Sawmills

ADA Transition Plan

Adopted on November 19, 2024

Sawmills Parks & Recreation Dept.

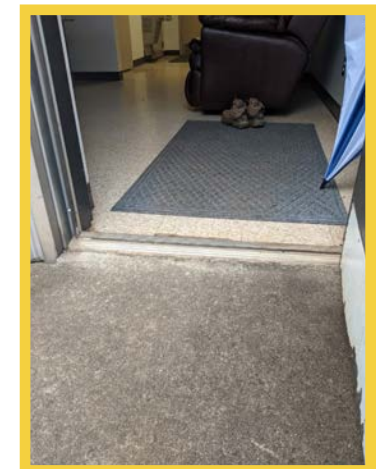
Threshold coming in at the exterior door could become a trip hazard.

Pipes should be insulated

Signage should be in Braille and mounted on the latch side of the door at regulation height.

Toilet paper dispenser needs to be closer to the toilet.

Sawmills Town Hall

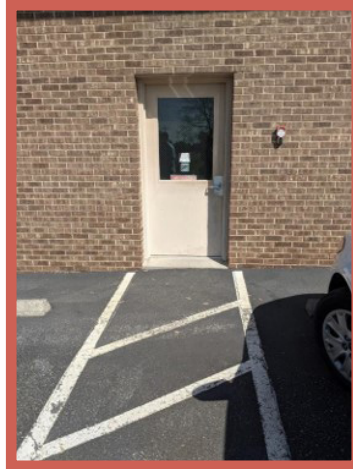
There are currently steps throughout Town Hall and no accessible route around them.

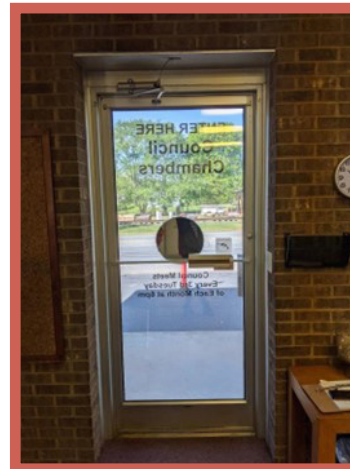
The back employee entrance may be a temporary option as an accessible route

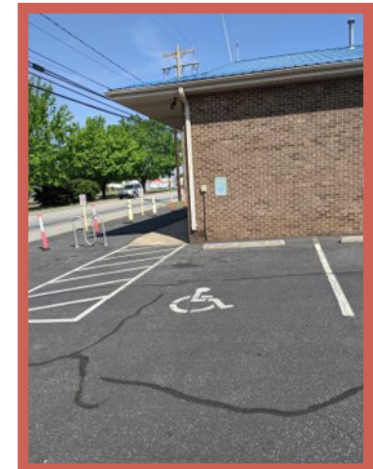
Several doorways throughout Town Hall were too narrow.

An accessible parking space must be present that is also van accessible.

Inaccessible entrances must have signage for the nearest accessible entrance.

Restroom

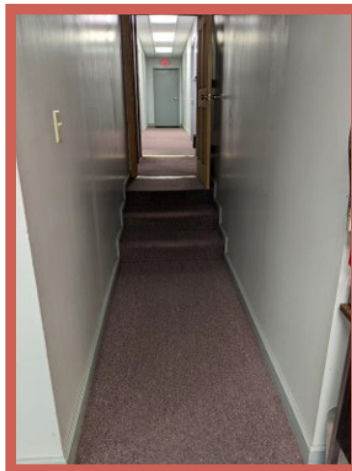
There is no accessible way to access the restroom

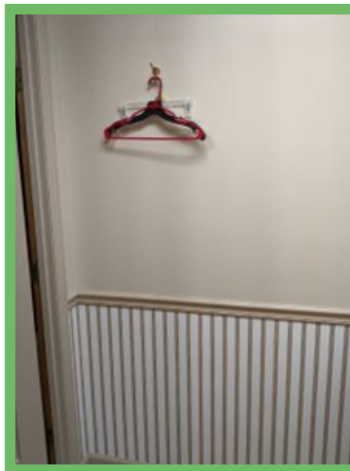
Accessible restroom signage should be placed on the latch side of the doorway.

Lower coat hanger.

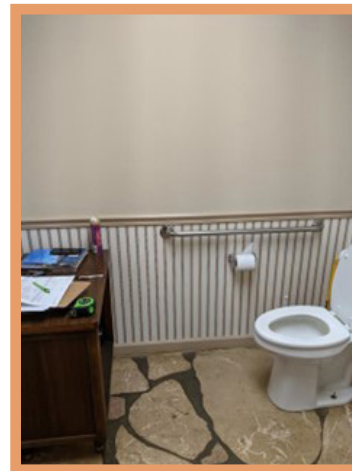
Currently not enough maneuverable space.

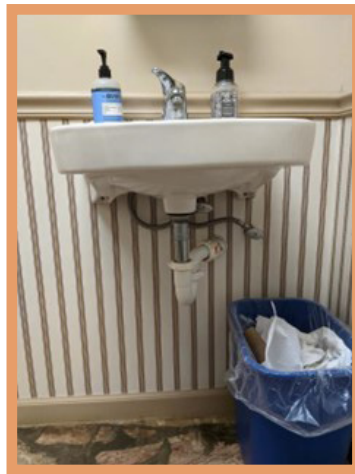
Lower mirror.

Fully insulate pipes.

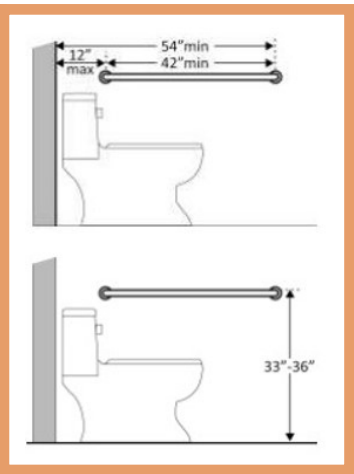
Side bar grab needs to meet designated requirements.

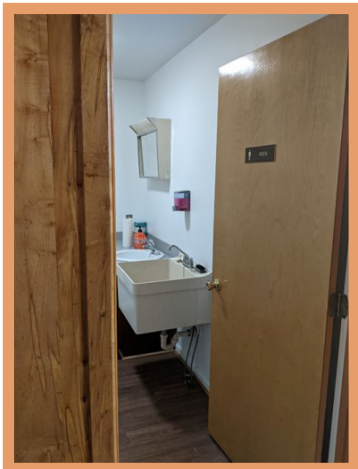
Signage should be in braille and mounted on latch side of door

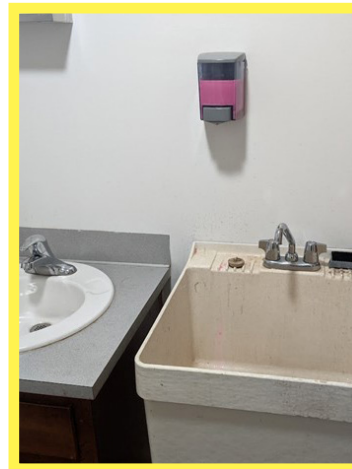
There is currently not enough clearance around the toilet

Soap dispenser should be mounted 48" high max when sink/counter is less than 20" deep

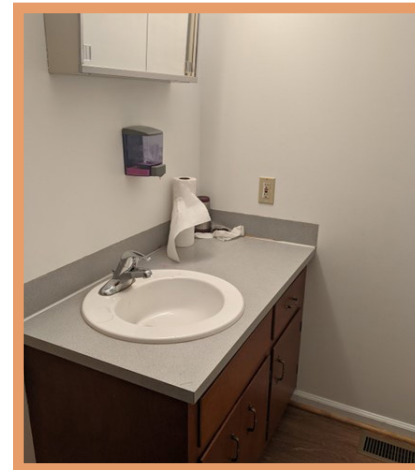
There is currently not enough clearance around the toilet

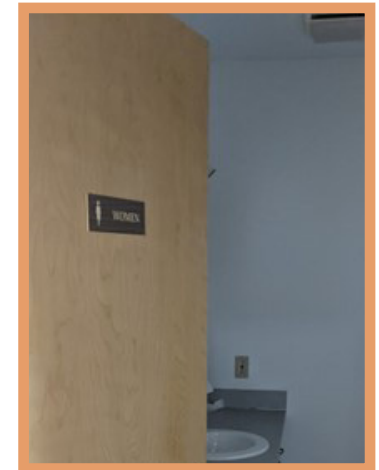
There is not enough knee space under the sink

Signage should be in braille and mounted on latch side of door

Parking Area

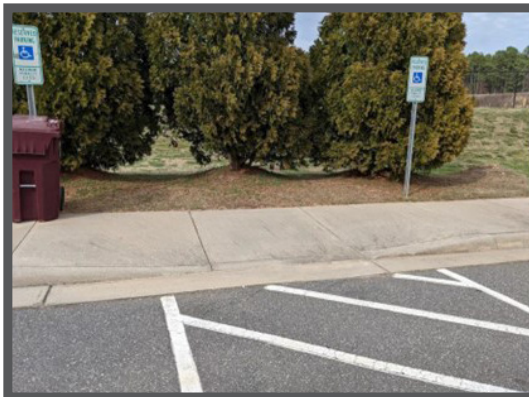
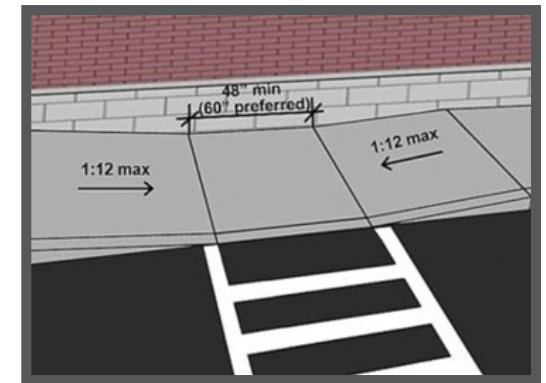
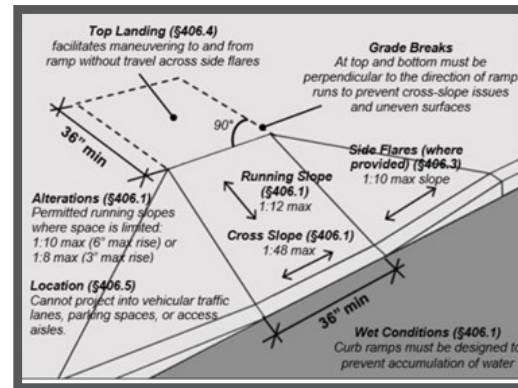
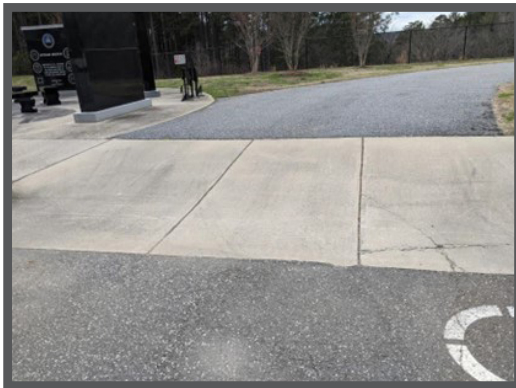
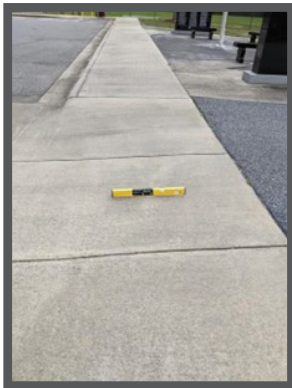
- » Driveway cuts that cross pedestrian routes must have a 2% or less cross slope.
- » The curb ramps at the accessible spaces (closest to the restrooms) have no level landing and creates a 5% cross slope for pedestrians using the sidewalk. Example curb ramp types are shown below. The first example shows a top landing that prevents pedestrian hazards when crossed. The second example shows parallel curb ramps used for confined spaces. The limited slope and flat landing prevents pedestrian hazards.

The curb ramp closest to the soccer field has a top landing right next to the stairs. Recommend high-viz striped tape on the stairs as well as directional signage showing the nearest accessible route. (high recommendation)

Lower Veteran's Park

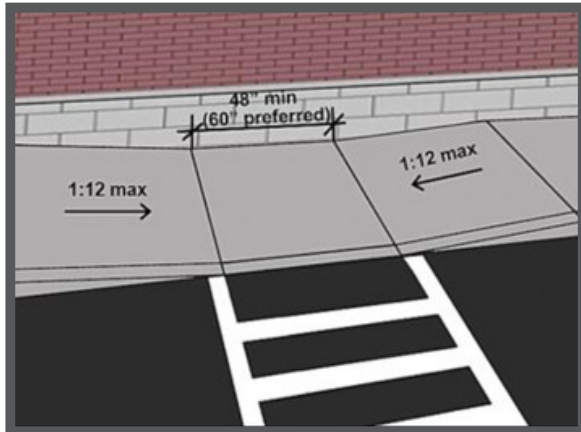
- » The curb ramps at the accessible parking spaces do not follow ADA measurements. The current curb ramps create an unsafe cross slope for all pedestrians. Please see the example below of a parallel curb ramp. The parallel curb ramp is the best fit for the space.

Parking at Lower Veteran's Park

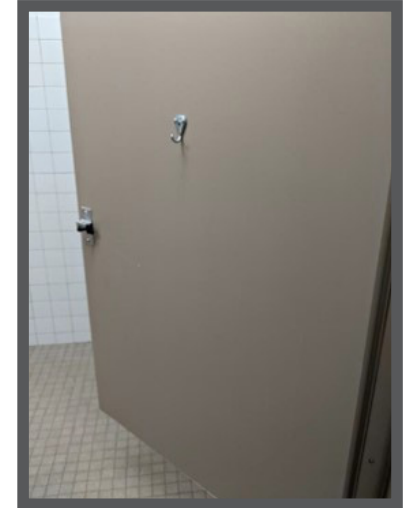
The 6th accessible space (far right) is not signed. Accessible signage must be posted 60" from the ground to the bottom of the sign.

Playground

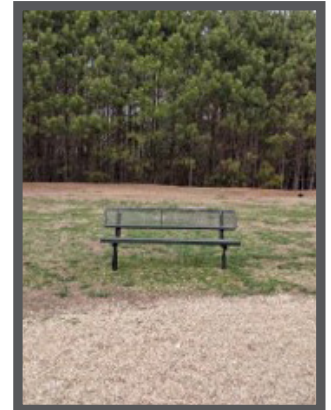
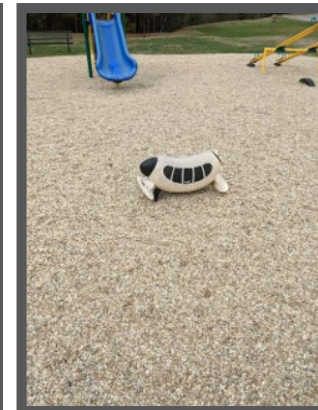
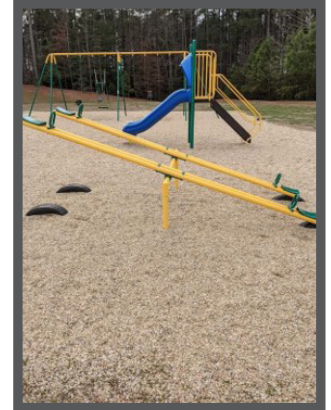
- » The current gravel surface in the playground is not ADA compliant.
 - » Appendix C.1 covers some of the stipulations for ADA playground and accessible route surfaces.
 - » Appendix C.2 covers multiple ground surfaces to consider in both play grounds and accessible paths.
 - » There must be an ADA accessible route to one of each park element. One bench, gazebo, seesaw, slide, bouncer, and swing must connect to the entry/exit of the park. The entry and exit of the park must also connect to the parking area via accessible route. This is the only way persons in wheelchairs (guardians or children) can safely access these elements.

- » Recommendation: There are currently no ADA Standards regulating disc golf. It is, however, recommended that a small portion of holes are accessible to all by means of accessible routes. Accessible routes are continuous, unobstructed paths connecting all accessible elements.
- » Recommendation: Accessible playground equipment is recommended for this park. Currently, there is no inclusive playground equipment.

US 321A & Sawmills School Rd

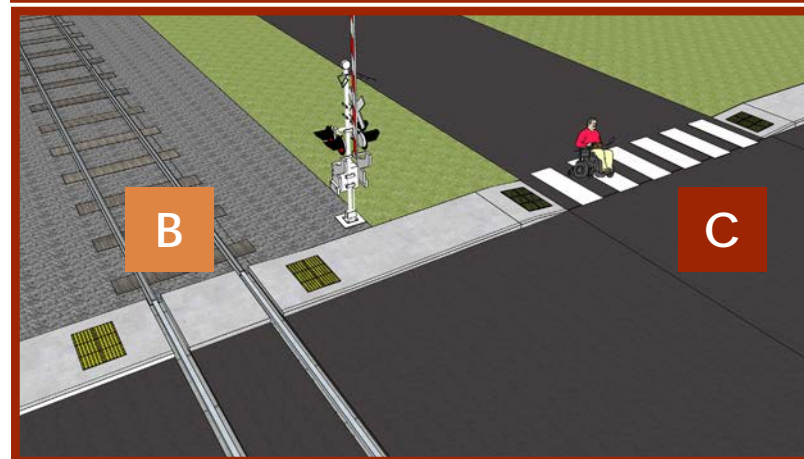
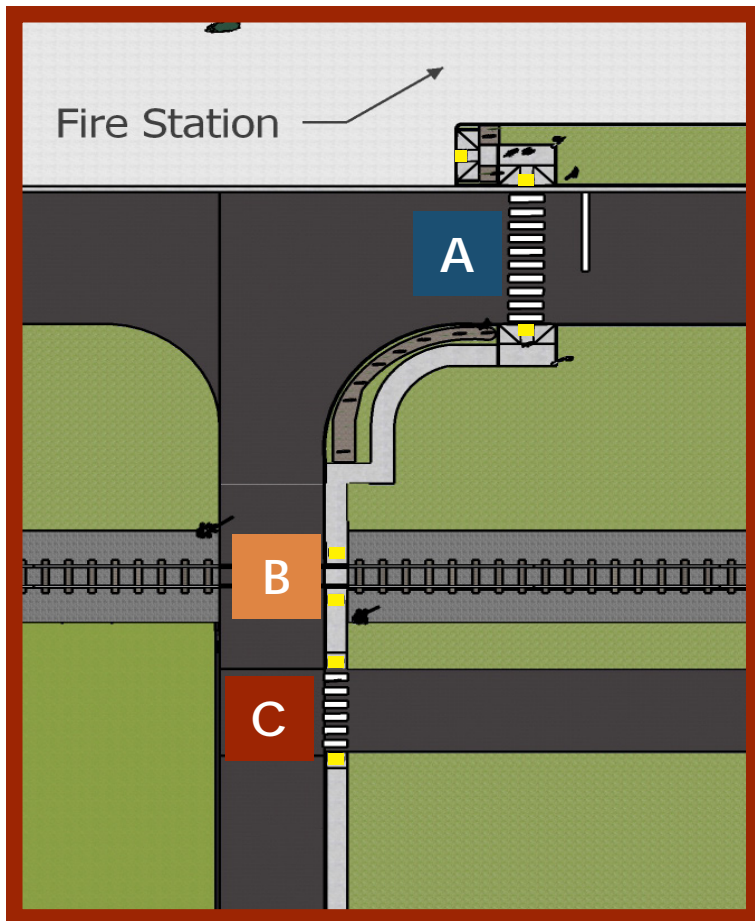
- » Curb ramps are needed on both sides of Sawmills School Rd at the intersection of Helena St.
- » Detectable warnings are required for curb ramps leading pedestrians into roadways.

Sawmills Elementary School Entrance

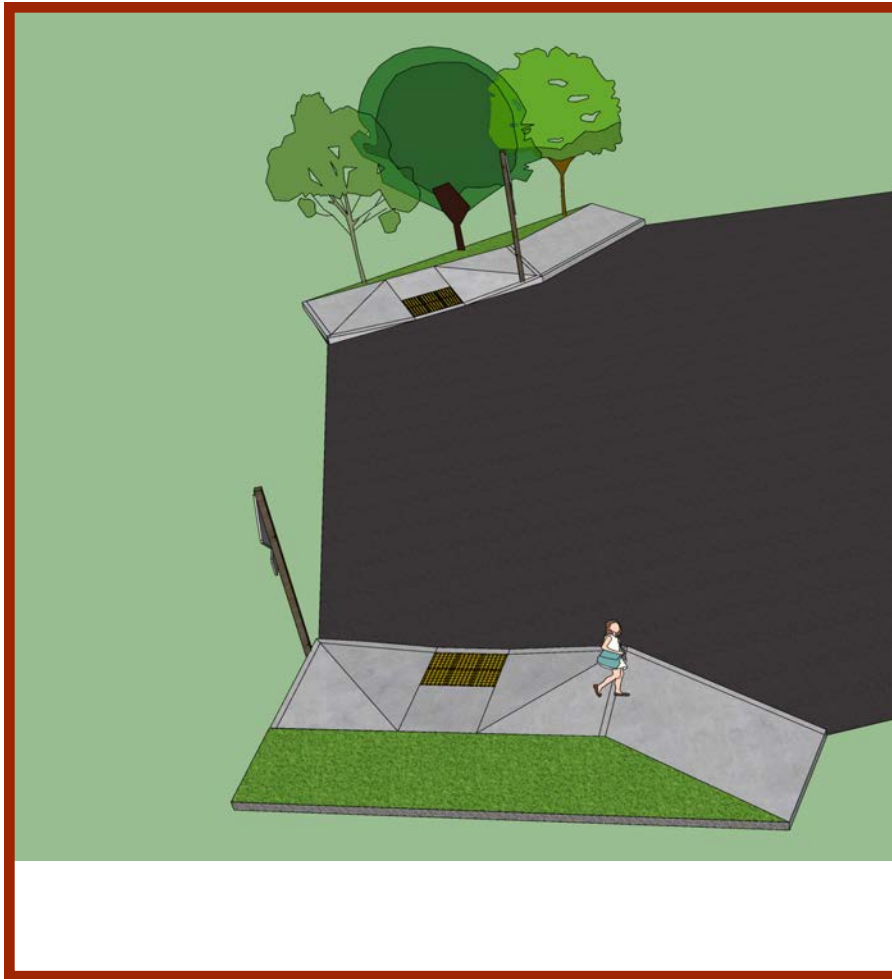
- A » High visual crosswalk with compliant curb ramps, detectable warnings, and pedestrian signage are needed at both ends of crosswalk.
